DATE: July 11, 2008
TO: Interested Parties
FROM: Joan A. Kugler, Senior Environmental Planner
RE: CASE NO. 96.281E: CENTRAL SUBWAY PROJECT (PHASE 2 OF THE THIRD STREET LIGHT RAIL PROJECT) COMMENTS AND RESPONSES

RESPONSE TO COMMENTS
VOLUME II
**FINAL SUPPLEMENTAL ENVIRONMENTAL IMPACT STATEMENT/
SUPPLEMENTAL ENVIRONMENTAL IMPACT REPORT**

FIGURE 2-16

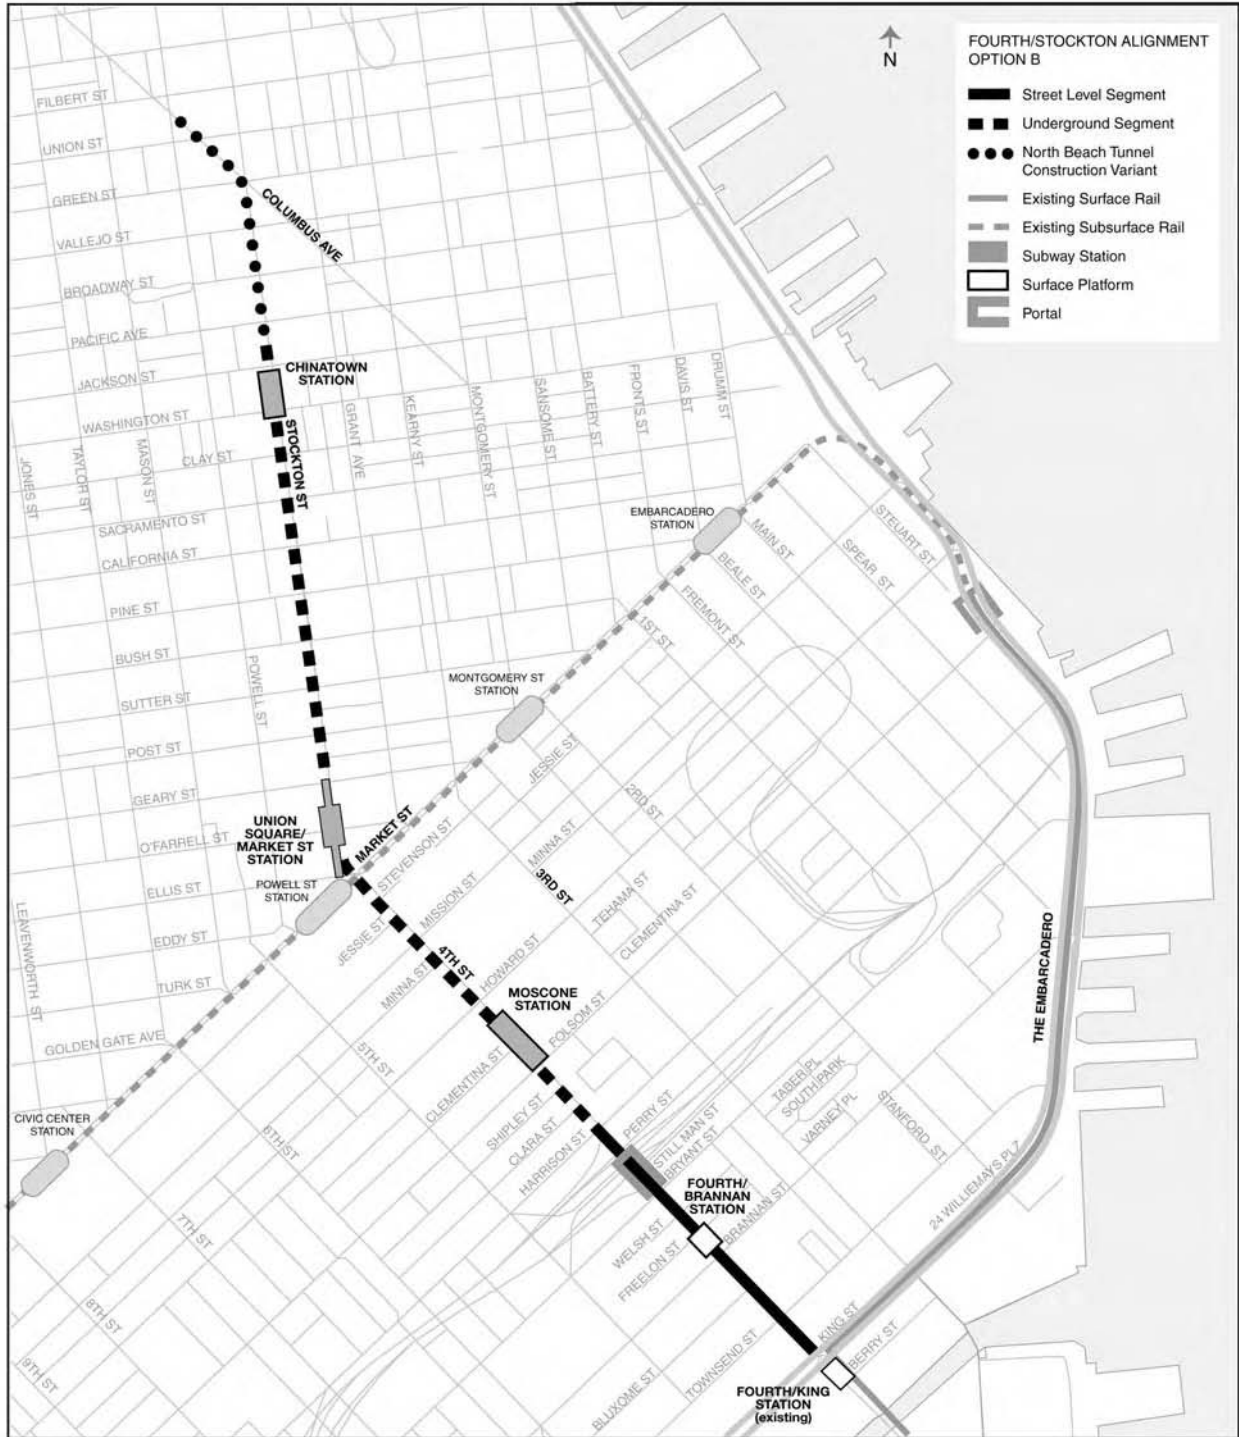
“After stopping at the station platform on Fourth at King Streets, light rail would continue north on Fourth Street to a double-track portal between ~~Bryant Perry~~ and Harrison Streets under I-80 (see Figure 2-16).”

Figures 2-16, 2-18, 2-19 and 5-10 are revised as noted in the attached pages to reflect the relocation of the subway portal and the placement of a crash barrier.

~~“Because of the location of t~~The portal on Fourth Street just south of Perry Street, under the Interstate 80 Freeway, has been located to accommodate the bus access from south-

FIGURE 5-10

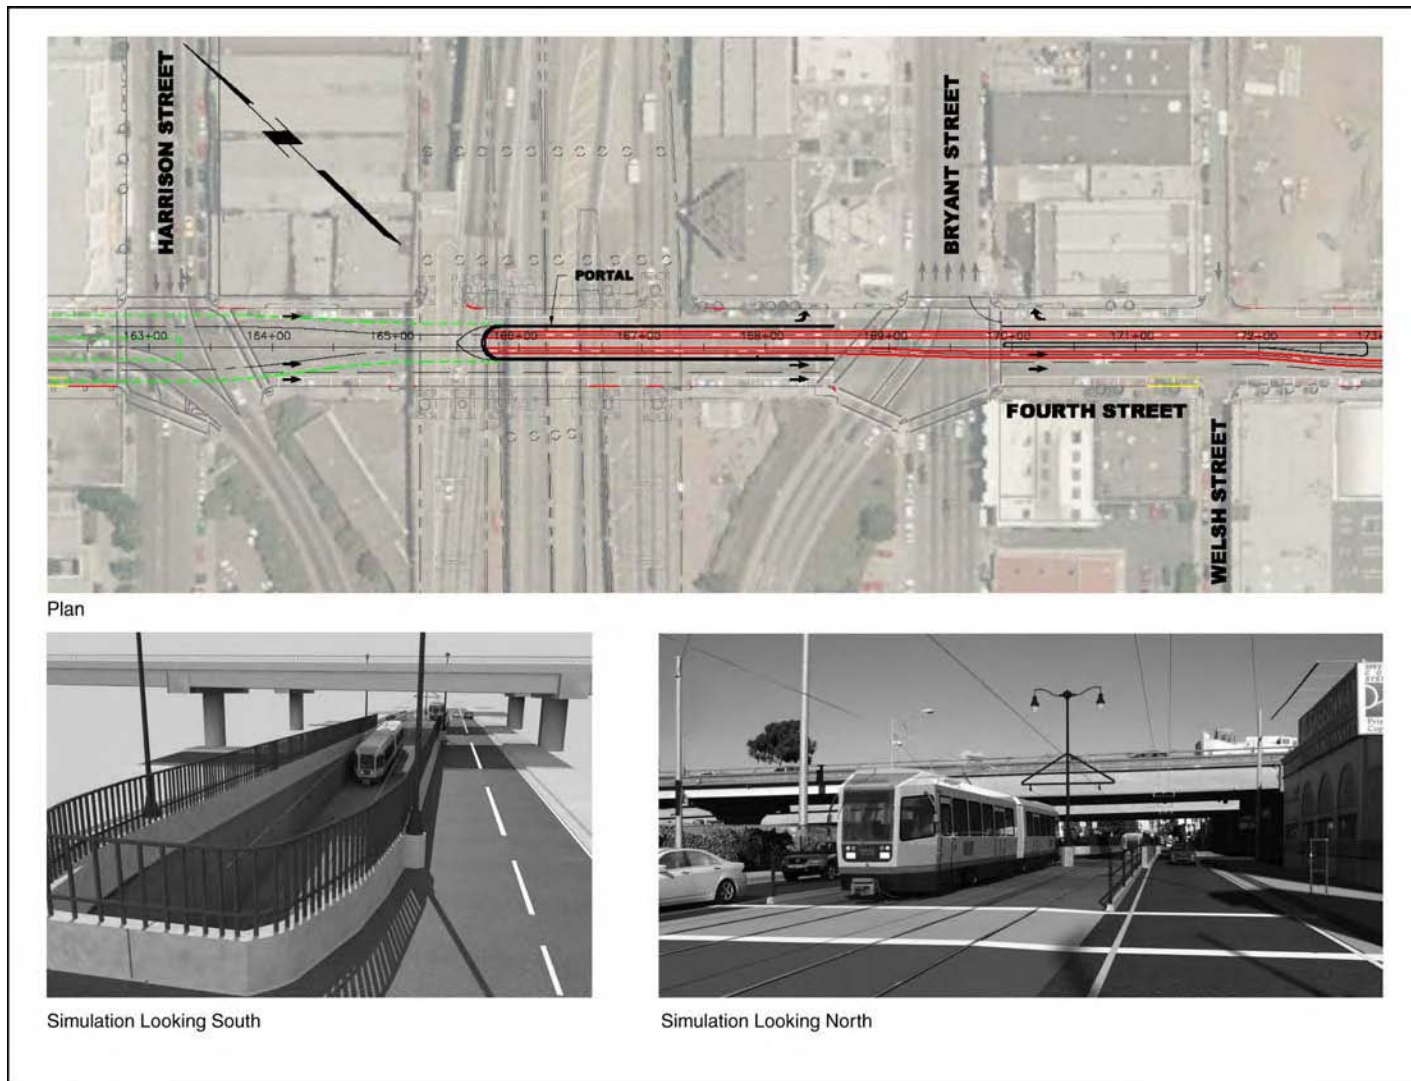
A crash barrier is planned for the portal to protect the entrance structure from turning buses. The current tunnel portal layout plans provide space for the tunnel crash barrier without interfering with the turning path of the bus as it enters the bus storage facility. Figure 2-18 on page 2-39, Figure 2-19 on page 2-41, and Figure 5-10 on page 5-40 have been revised to show the tunnel crash barrier. See Response to Comment R-1 for revised figures.

Figure 4-4

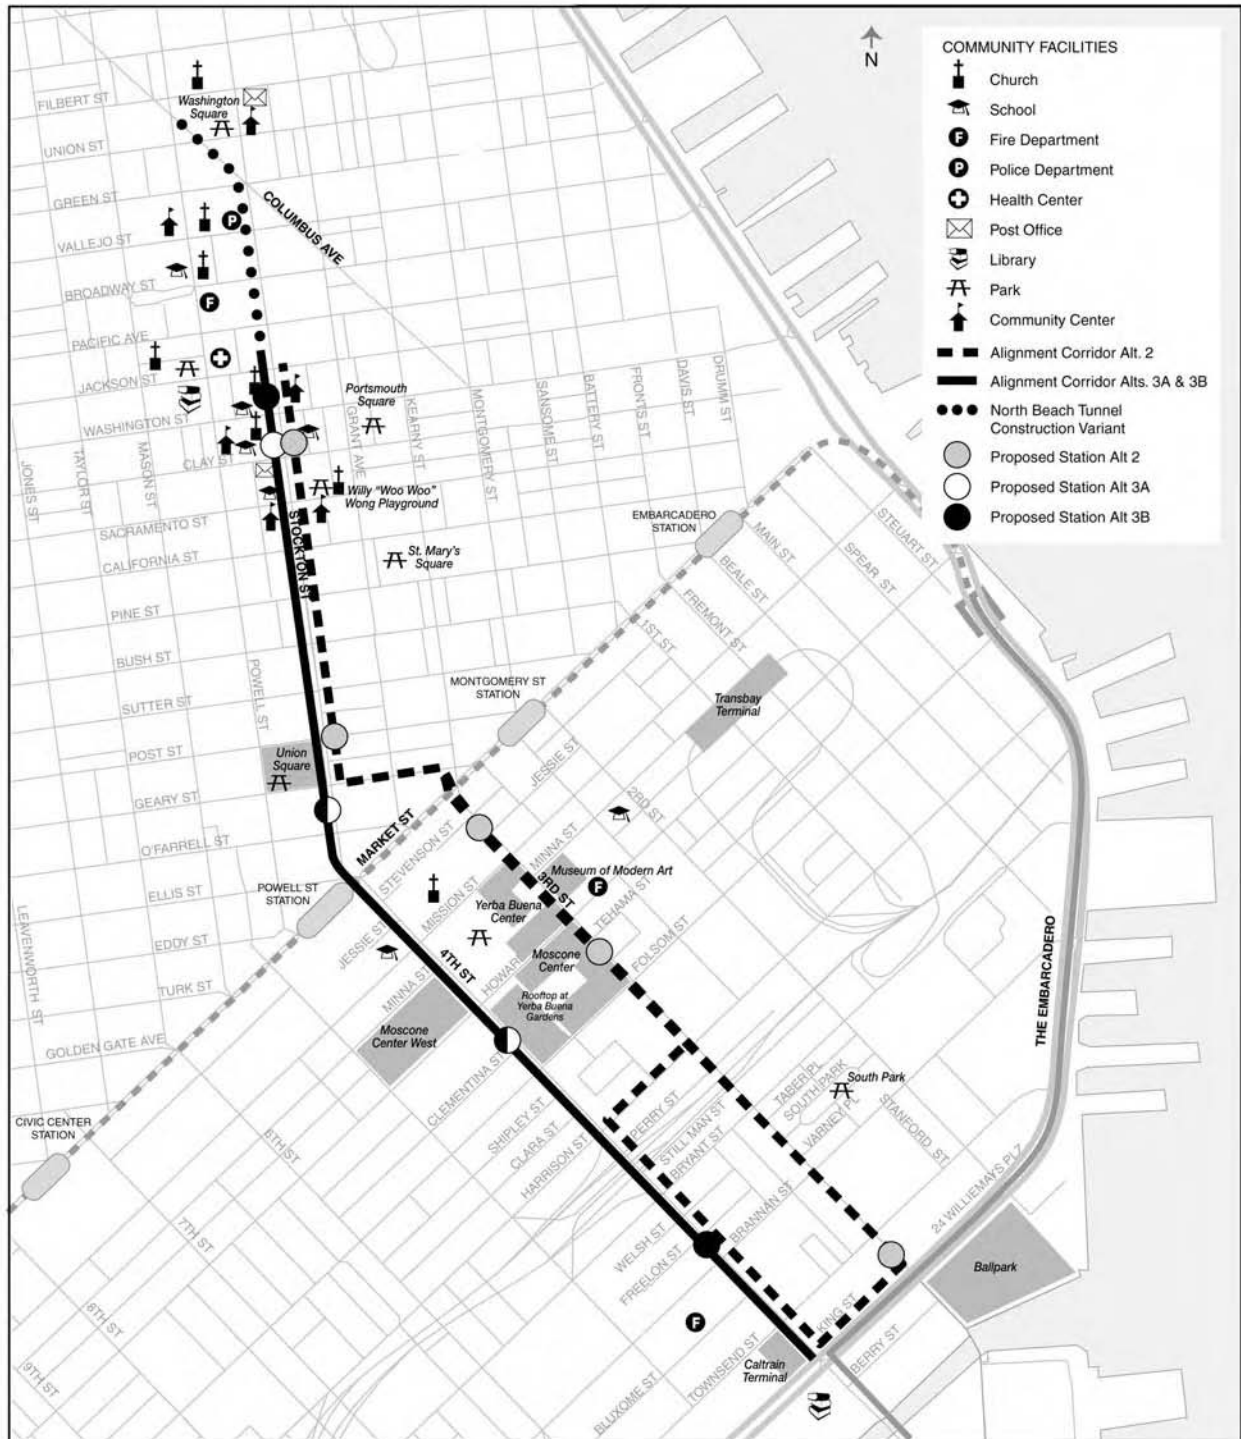
Figure 4-4 on page 4-36 is amended to include the Chinese Historical Society, Donaldina Cameron House, Chinatown YMCA, First Chinese Baptist Church, and Presbyterian Church in Chinatown.

FIGURE 2-29
THIRD STREET LIGHT RAIL
PHASE 1 INITIAL OPERATING SEGMENT AND PHASE 2 1998 FEIS/FEIR CENTRAL SUBWAY

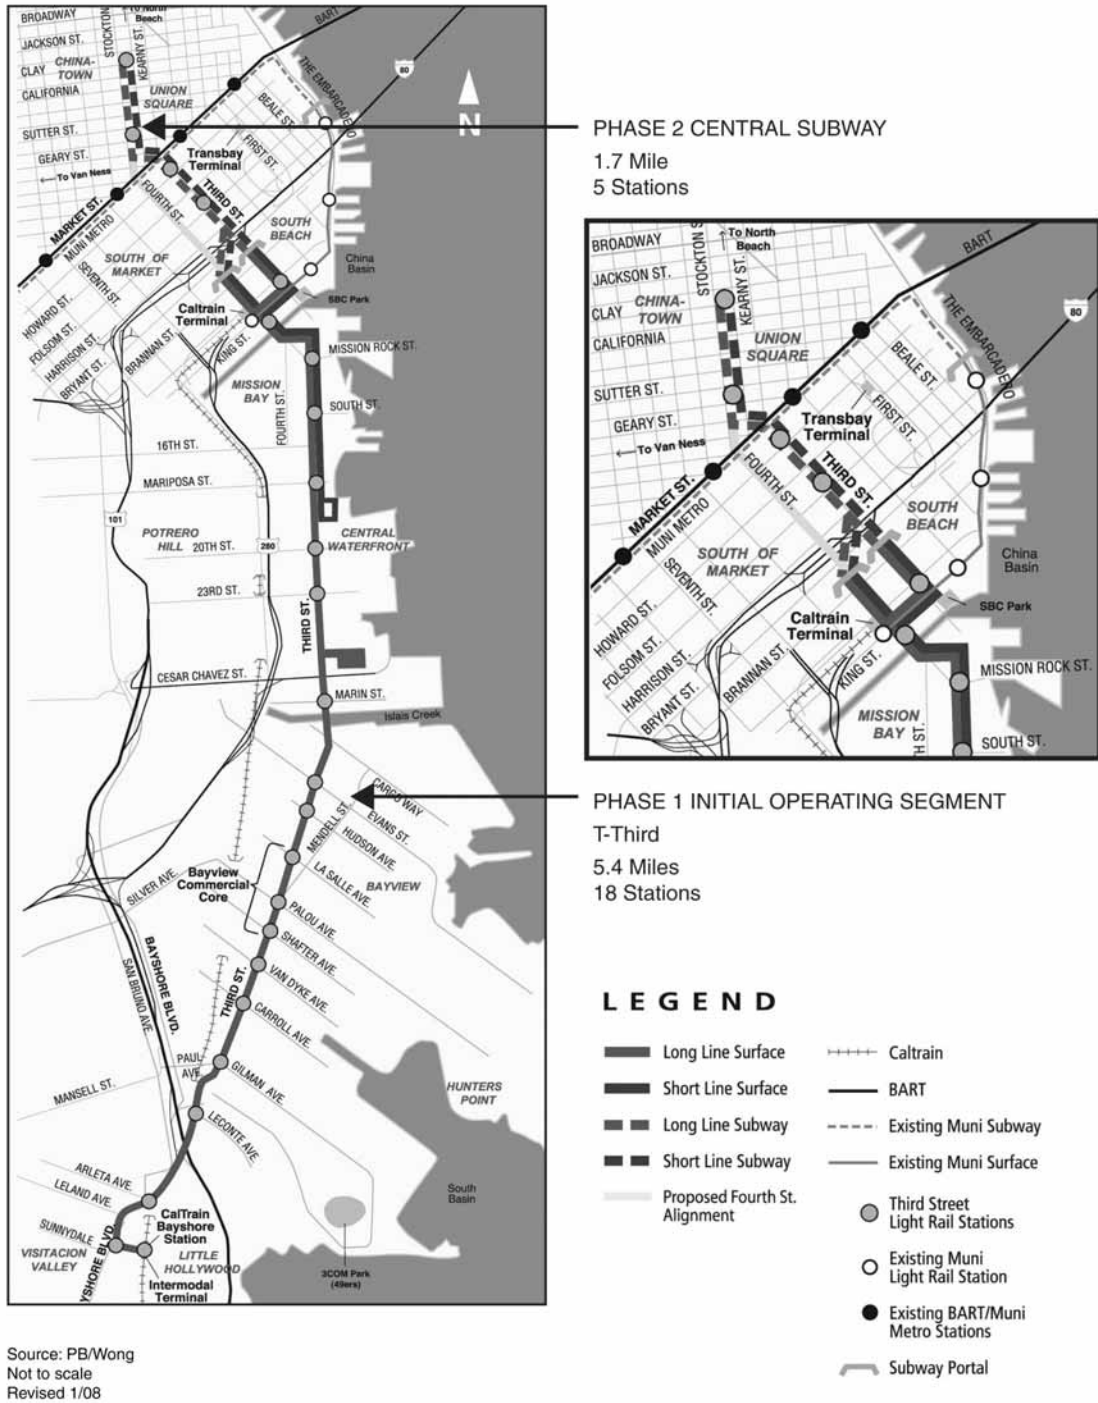
Figure 2-29, page 2-53 is revised to correct the number of stations in the original Central Subway Project (5 stations) and to correct the miles in the T-Third operation (5.4 miles) as shown on the following page.

FIGURE 3-3

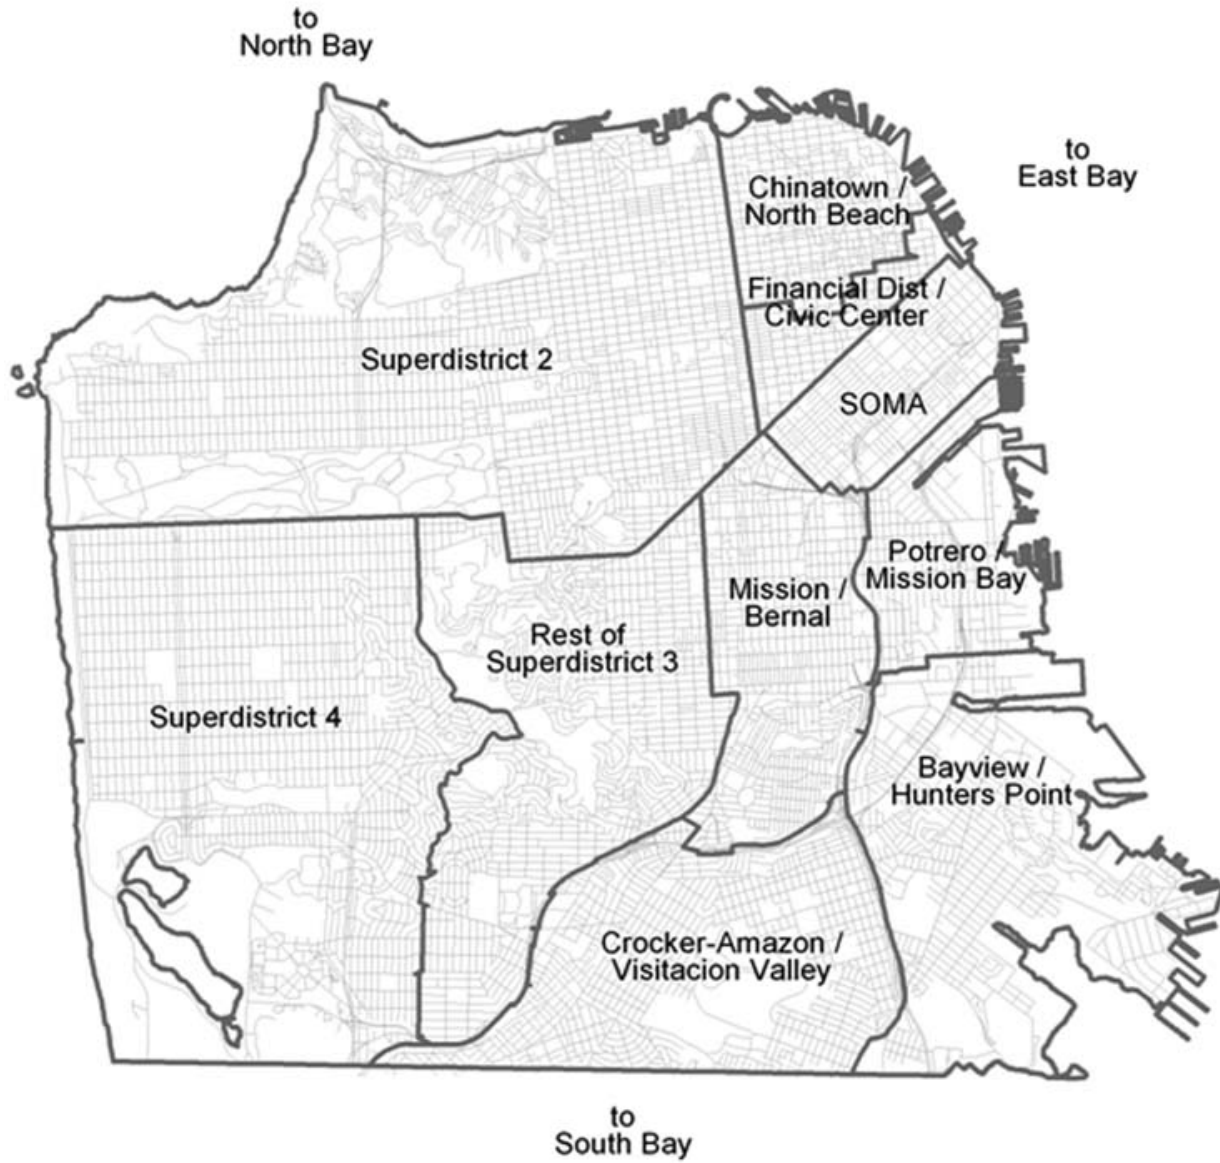
Figure 3-3, page 3-12 is revised to correct the spelling error of Civic Center as shown on the following page.
